Technical Specialist Memo - Groundwater

Date: 19 September 2025

Fast-Track project name: Drury Quarry Expansion – Sutton Block

Fast-Track application number: FTAA-2503-1037 (EPA reference) + BUN60449474 (Auckland Council reference)

Proposed Monitoring Bores to East of Hunua Fault

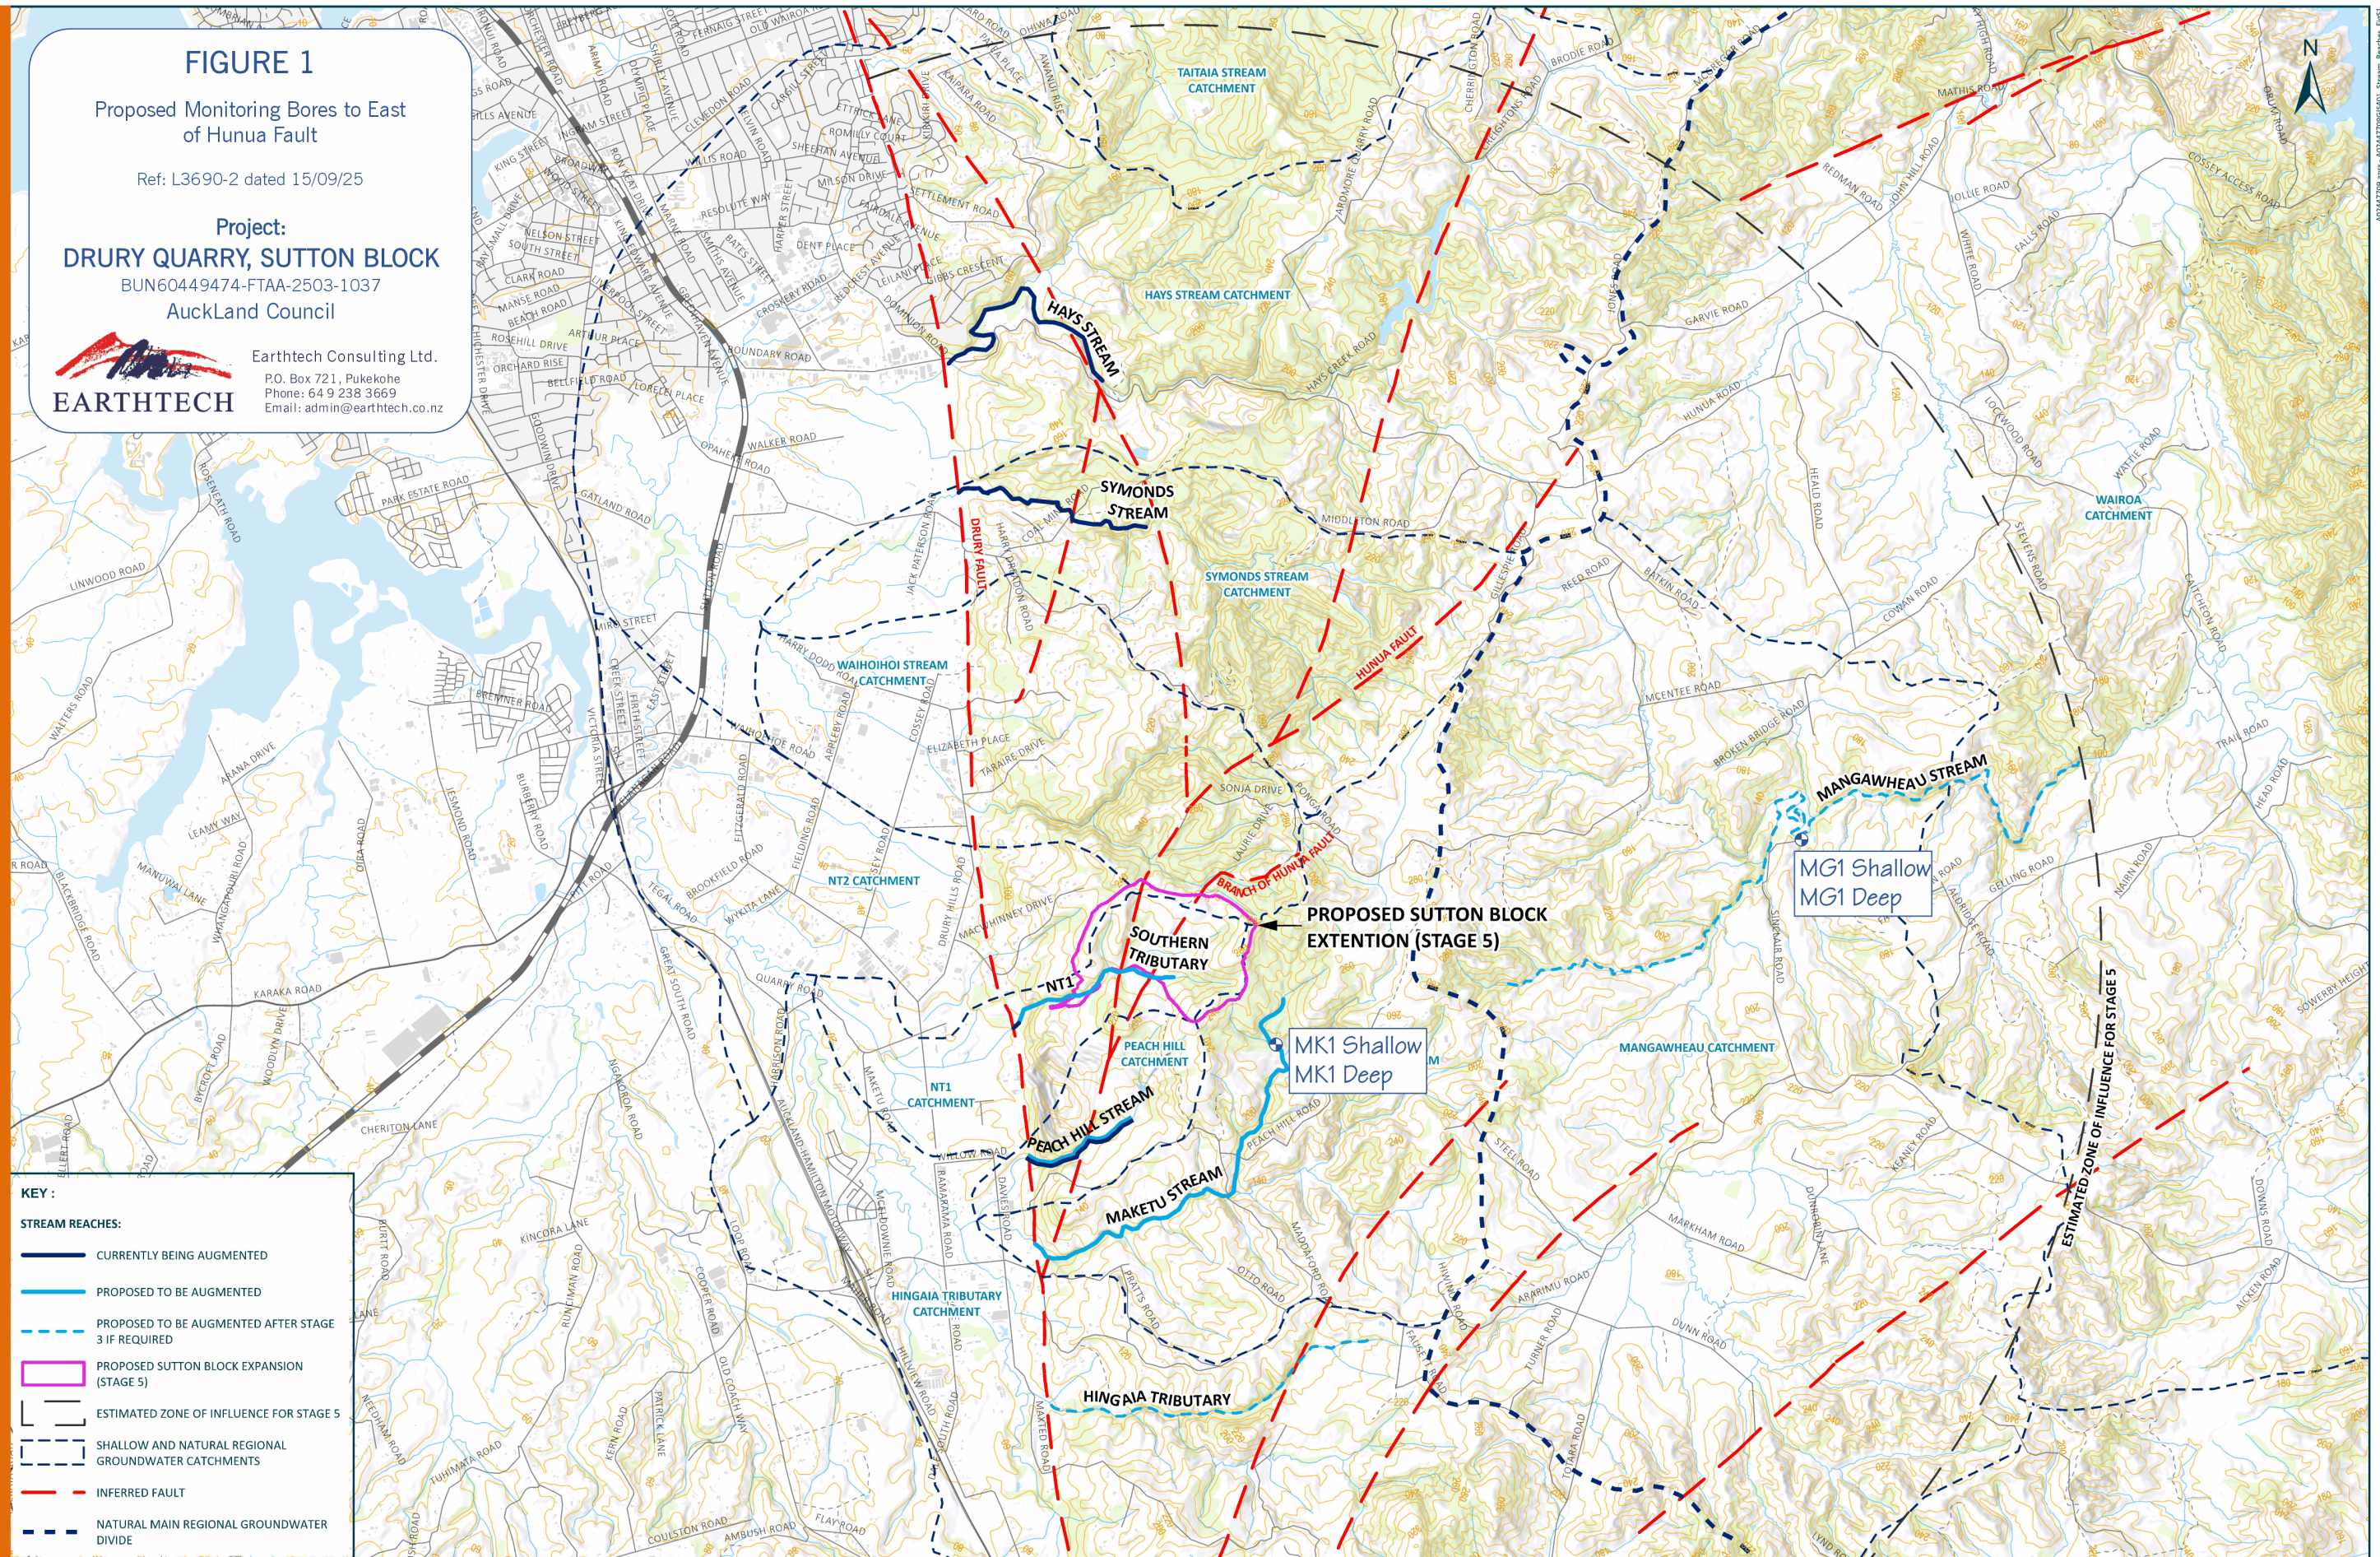
Quarry dewatering drawdown is expected to reduce baseflows to a number of streams within the 7.5km radius zone of influence. The attached Figure 1 “Proposed Monitoring Bores to East of Hunua Fault” shows the predicted reduced baseflow effects for:

Amendments to stream augmentation conditions 138 to 164 are proposed. Figure 1 shows two additional bore locations to the conditions set with:

- i. MK1 shallow and deep from PDP (2025c). Located in upper Maketu Stream catchment.
- ii. MG1 shallow and deep proposed by the reviewer, located in Mangawheau Stream catchment.

The MK1 and MG1 bores are required to monitor groundwater drawdown associated with baseflow reduction effects. PDP(2025d) supports the MK1 bore pair with installation within six months following the issuing of the consent. The reviewers recommended MG1 pair is not supported by PDP(2025d) on the basis of expected drawdown being less than the about 20m predicted by the envelope of effects.

The reviewer remains of the view that the MG1 bore set is still required as there is no monitoring proposed between distances of 1km (at MK1 where 100m of groundwater drawdown is predicted) and the 7.5km radius of dewatering influence. The applicant is not proposing any specific groundwater level monitoring within the Mangawheau Catchment where stream augmentation may be required after Stage 3 Quarrying (See attached Figure S1). The conditions attached to this Tech Memo propose both MK1 and MG1 bore sets being required.

Figure S1 shows the Hays Stream, Symonds Stream, lower reaches of NT1 and Peach Hill Stream as currently being augmented. Augmentation is being carried out by the existing Drury and Hunua Quarries. All of these augmented streams are located within the predicted zone of dewatering influence of the Sutton Block quarrying.

- i. New monitoring bore set MG1 shallow and deep in Mangawheau Catchment – added to Schedule A of conditions.
- ii. Proposed new Conditions 165 to 170.
